**Subject: Request for Modification to Individual Section 404 and 401 permits and Neuse Riparian Buffer Authorization** for construction of the SR 1923 Extension (Booker Dairy Road) from US 70 Business to US 301 in Johnston County. Federal Aid Project No. STP-1923(2). State Project No. 8.2312101. TIP No. U-3334. Debit \$570.00 from WBS 34929.1.1.

**References:** Section 404 Individual Permit issued March 17, 2009 (SAW 2008-02482);  
Section 401 Water Quality Certification and Neuse Riparian Buffer Authorization issued November 4, 2008 (DWQ No.20081106).

**Permit Drawing**  
**Sheet 9 of 26**  
revised 7/6/09

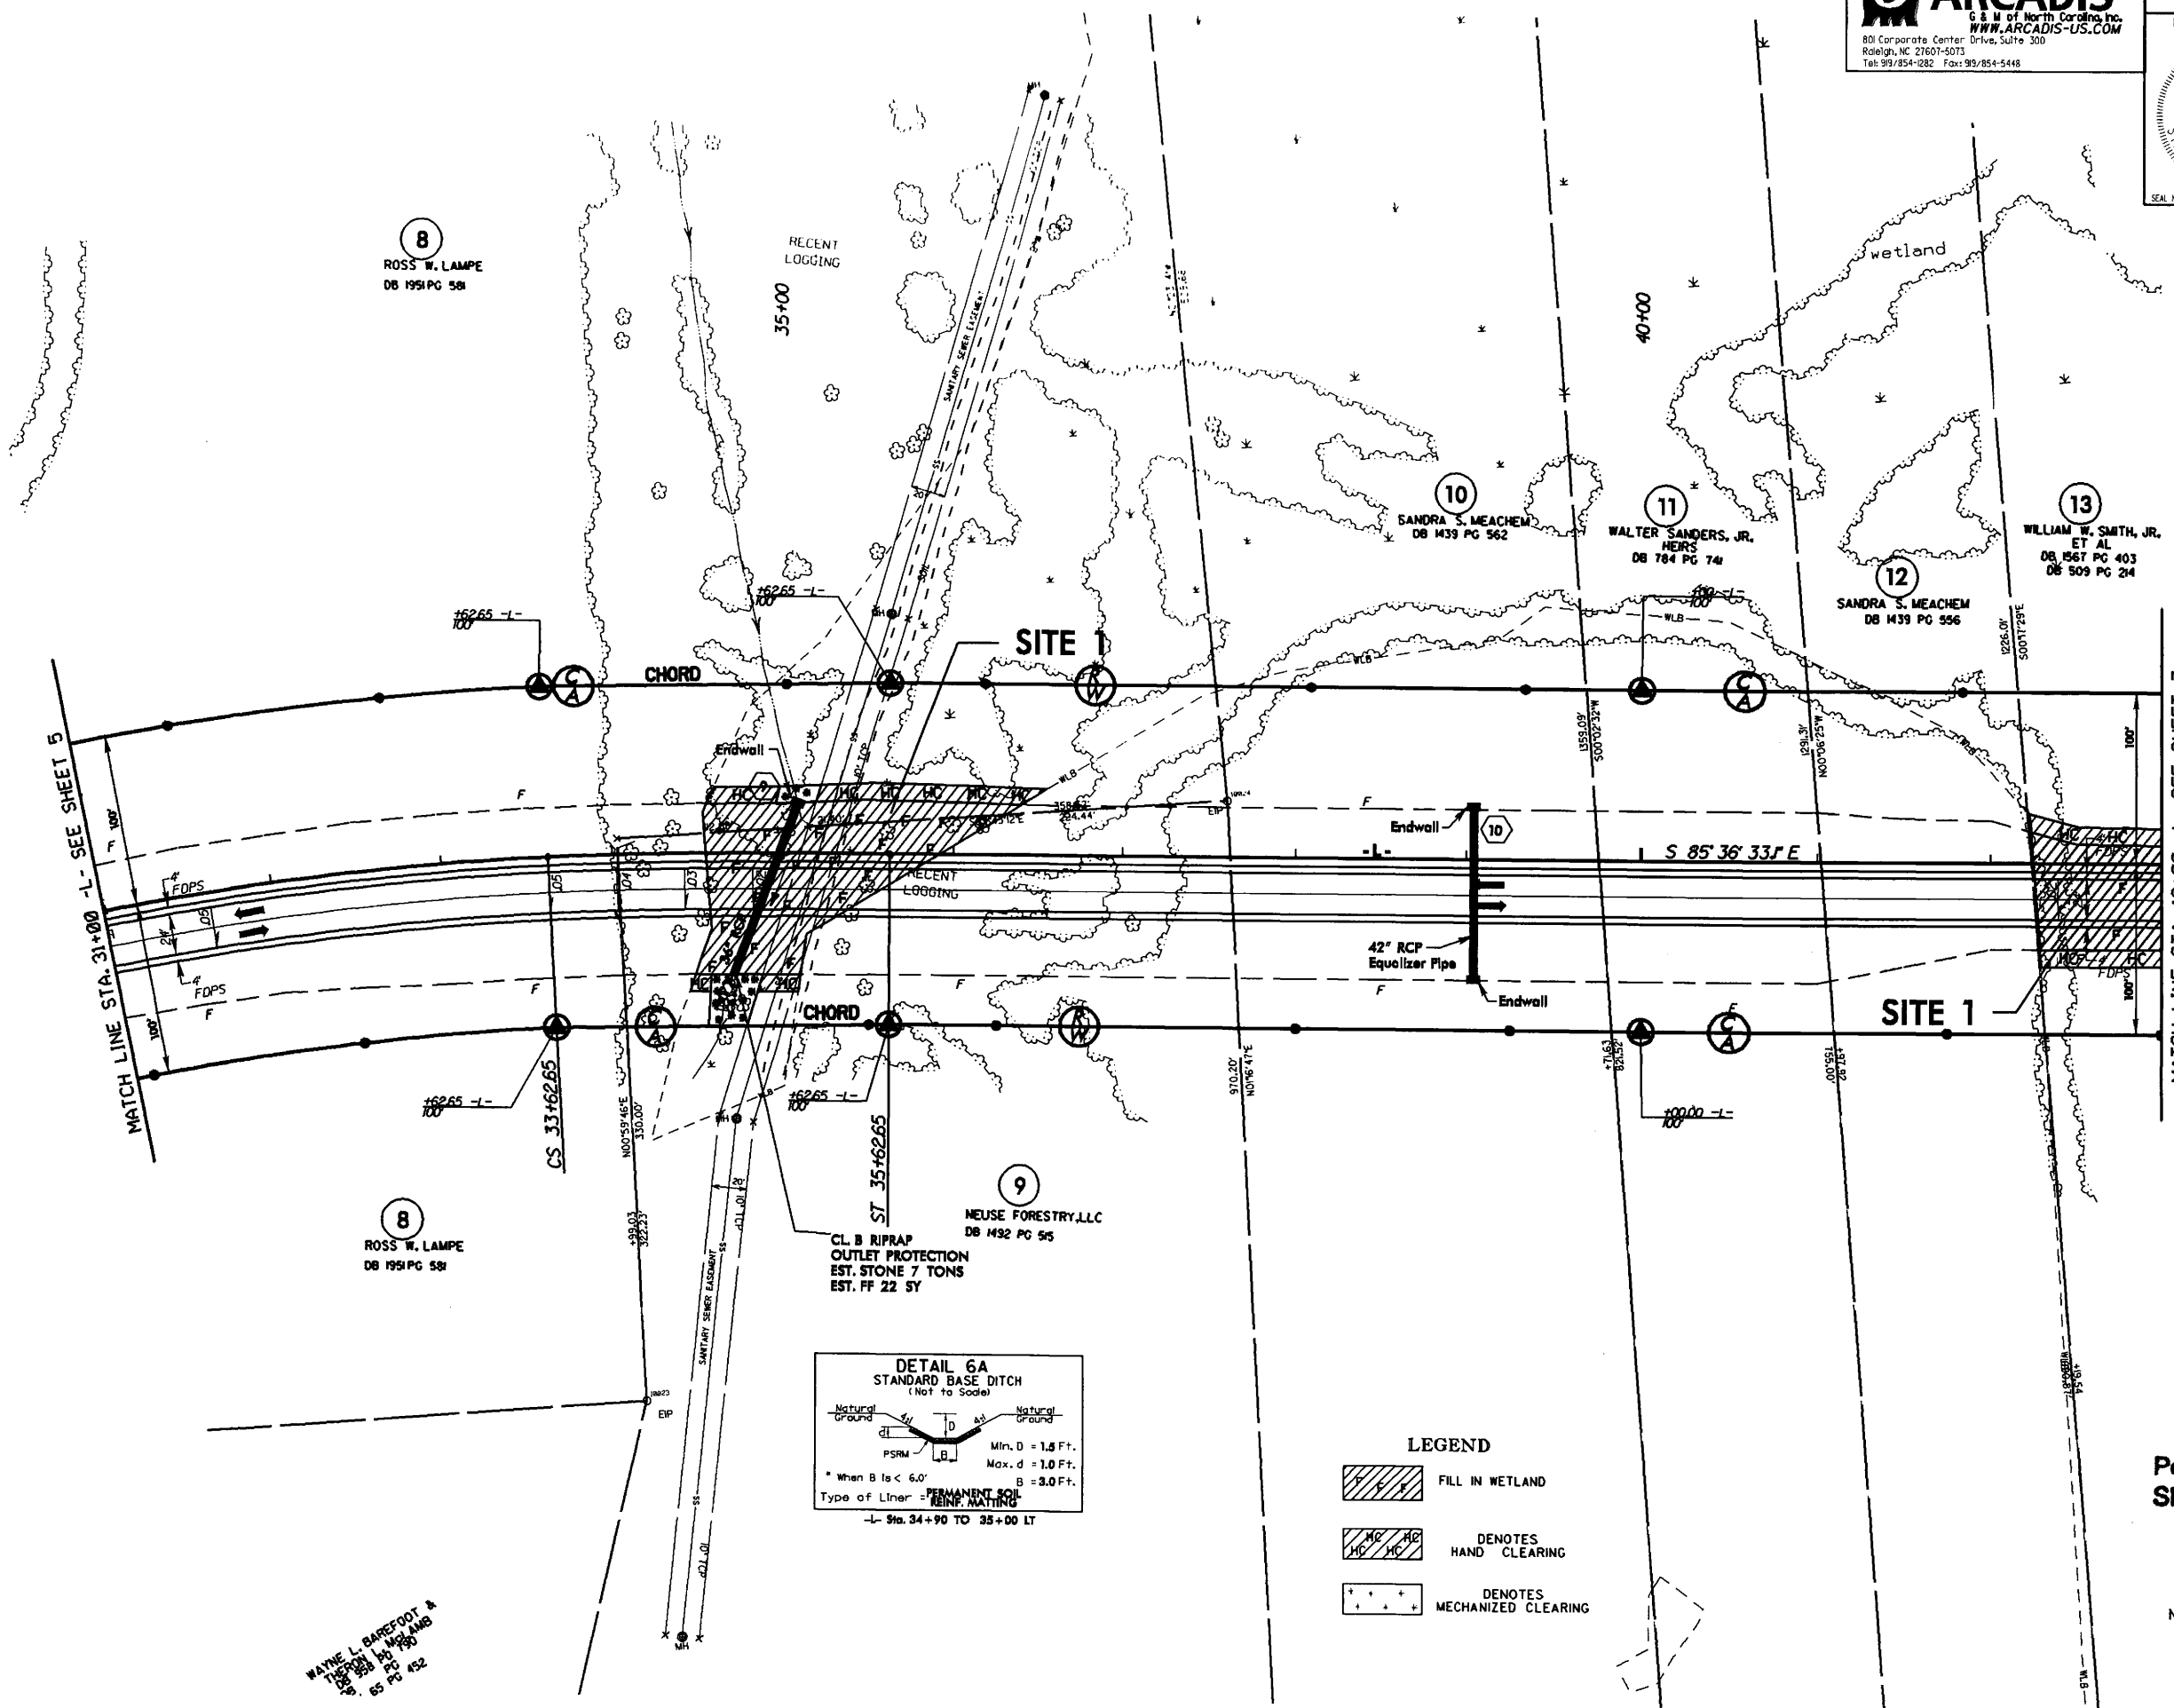
- Wetland site 1: a base ditch (station 35+00 RT) is shown extending beyond the fill line as permitted by the USACE and NCDWQ. NCDOT is proposing to move the inlet of the 36" RCP at this station to eliminate the unpermitted impact associated with the ditch. On the opposite end of this ditch (station 35+00 LT), a Class B Outlet Protection dissipation pad is shown extending approximately 25 feet outside the permitted fill line. NCDOT is requesting <0.01 acre of permanent fill for the pad and an additional 0.02 acre of mechanized clearing to install this device. In addition, the impacts associated with the sewer pipe being replaced east of this ditch

did not account for temporary ground disturbance around the pipe itself outside the permitted fill line. However, NCDOT is proposing that the work area required for the installation of the sewer line be confined to the existing sewer easement for the Town of Smithfield. Given that this easement is 20' wide and maintained in an herbaceous state, the maximum amount of hand-clearing, if needed, would be 0.04 acre. Finally, there are 4 equalizer pipes at wetland site 1 that extend into hand-clearing areas outside the fill slope. Division 4 has asked that 0.03 acre of hand-clearing originally permitted be replaced with mechanized clearing in these areas to perform the pipe installation. With these changes, permanent wetland impacts at this site now total 1.96 acres.

Permit Drawing  
 Sheet 10 of 26  
 revised 7/6/09

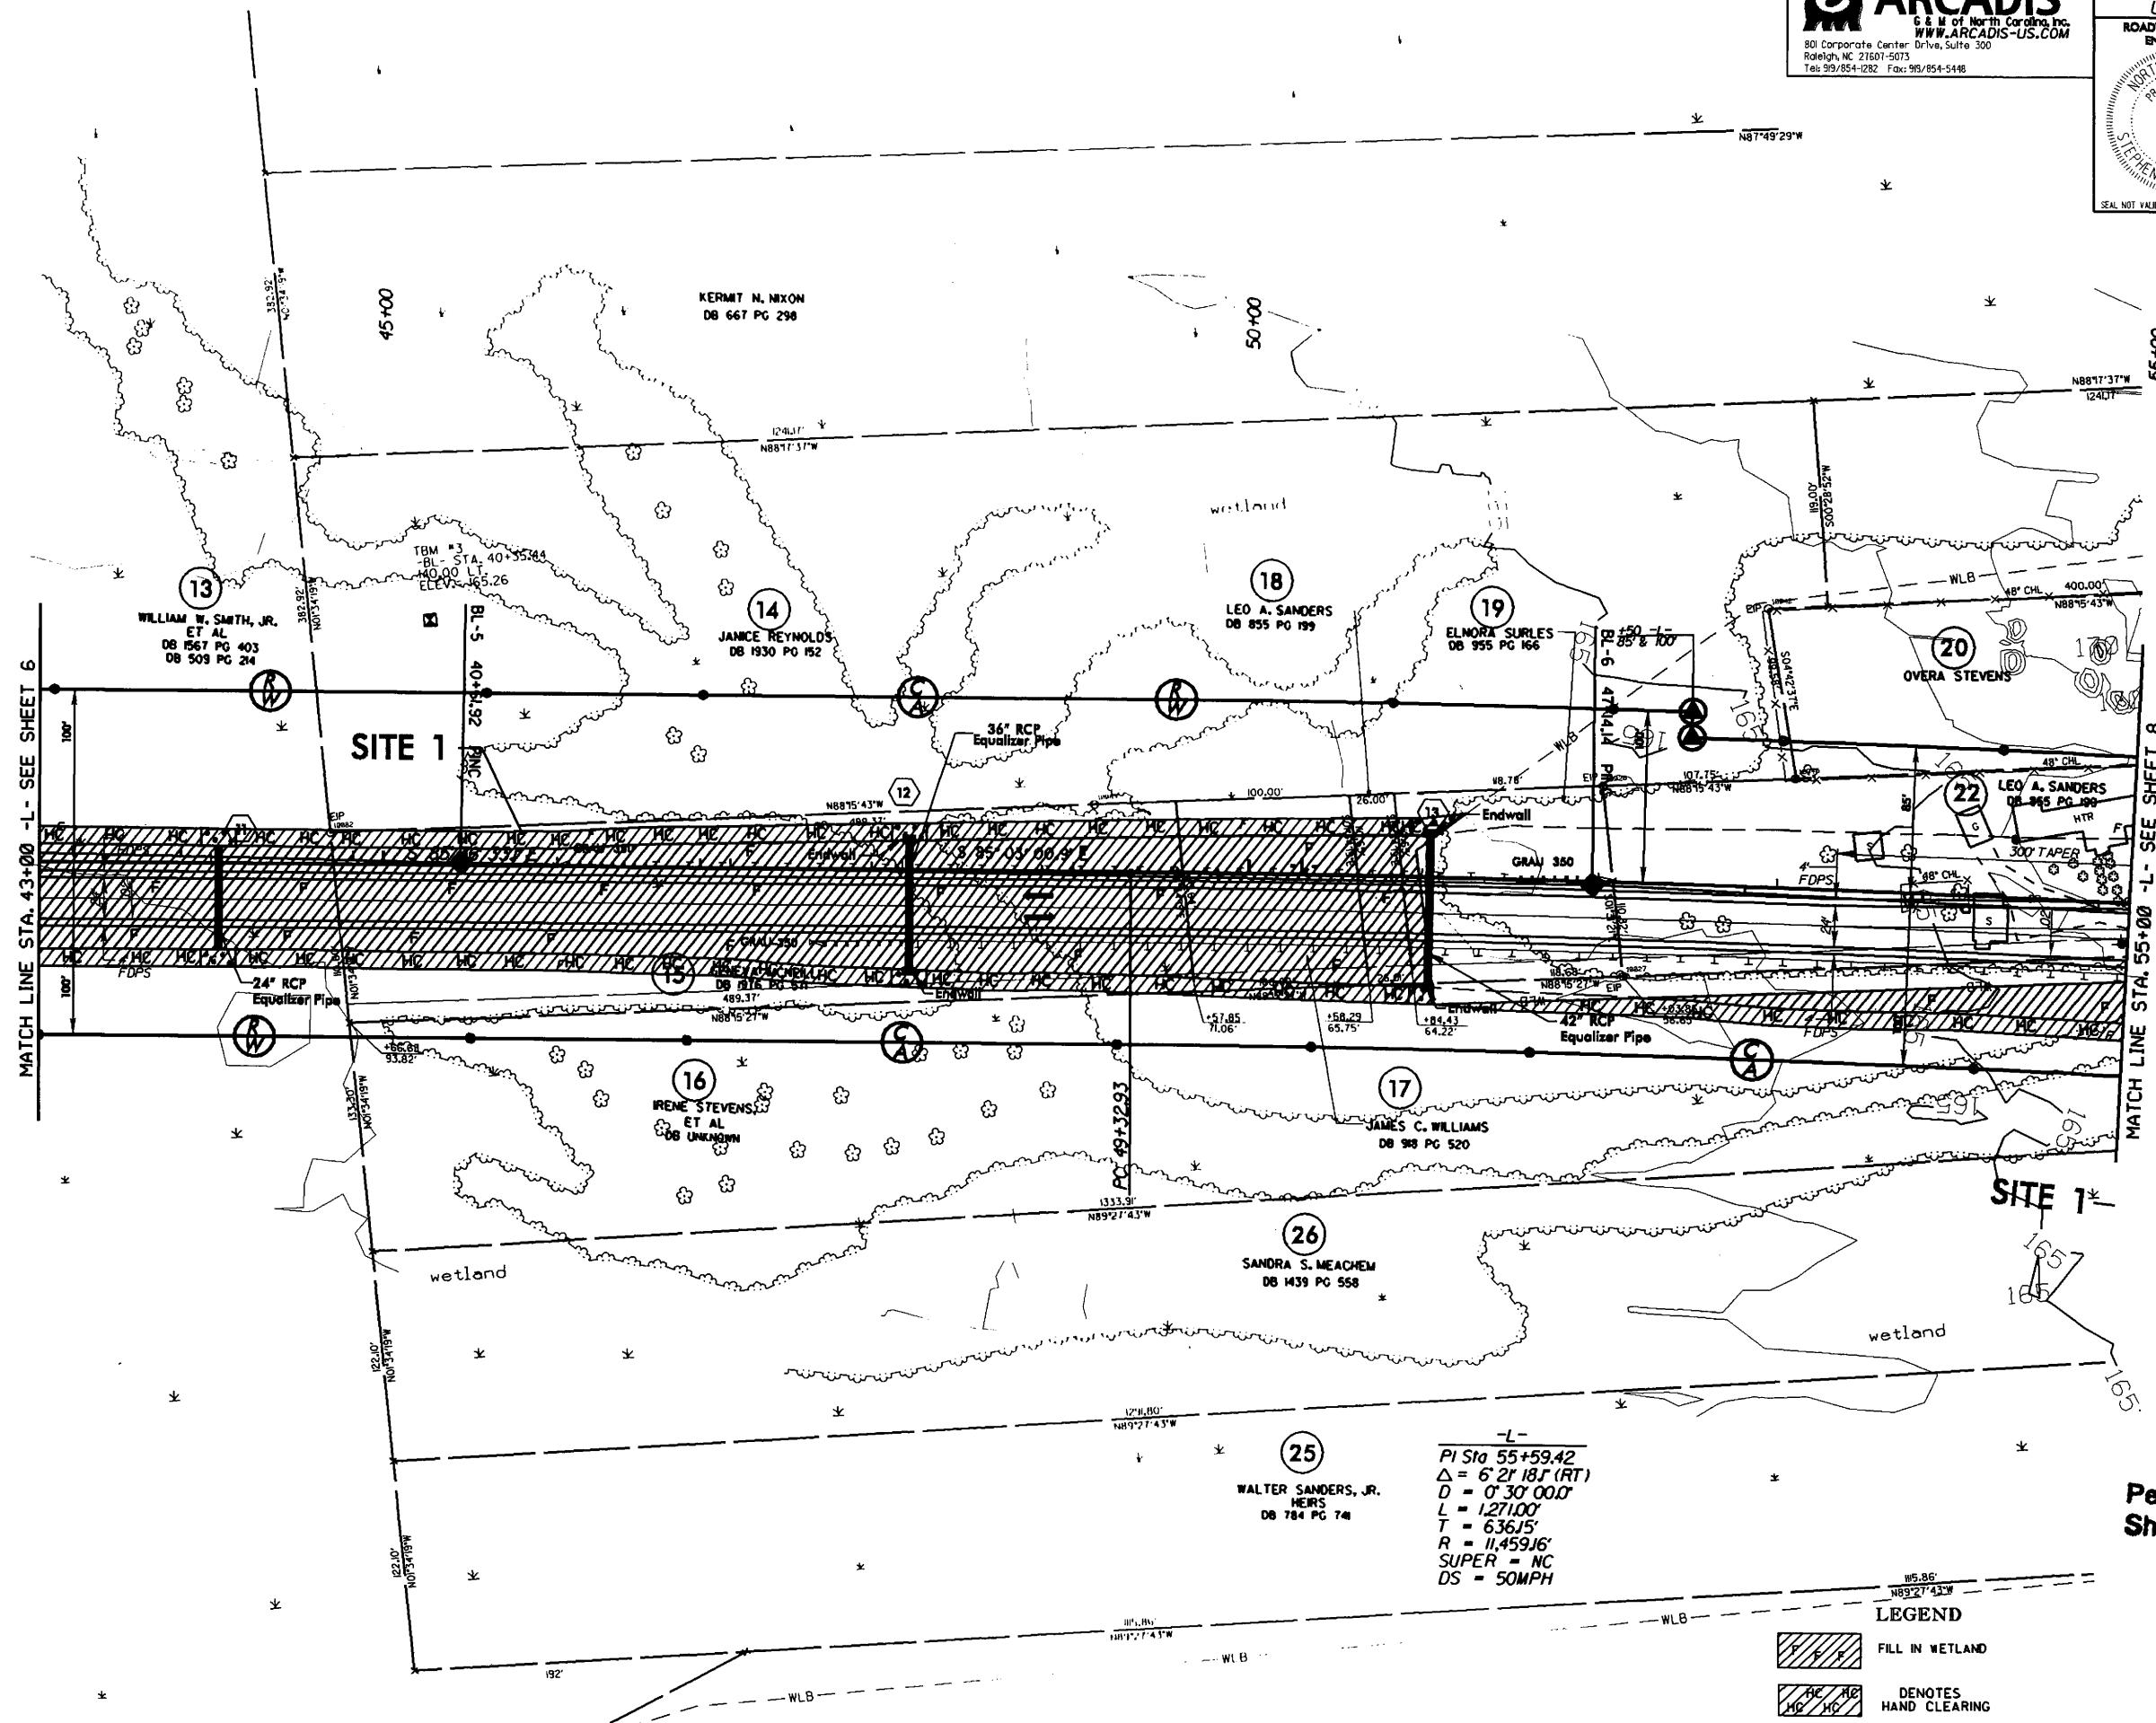
- Wetland site 2, a Class B Outlet Protection dissipation pad is to be installed in an area only permitted for hand-clearing by the plans. Therefore, NCDOT is requesting <0.01 acre of permanent fill for the pad and an additional 0.02 acre of mechanized clearing at this site to perform the needed work. Therefore, the total amount of permanent wetland impacts at this site is now 0.07 acre.
- Wetland site 5: NCDOT is requesting an additional 9 linear feet of stream impacts due to a miscalculation in the original permit application. The total amount of permanent impacts at this site should be 78 ft.
- Buffer site 3: a 42" RCP is replacing the 36" RCP that was originally permitted. This change does not result in any additional buffer impacts.
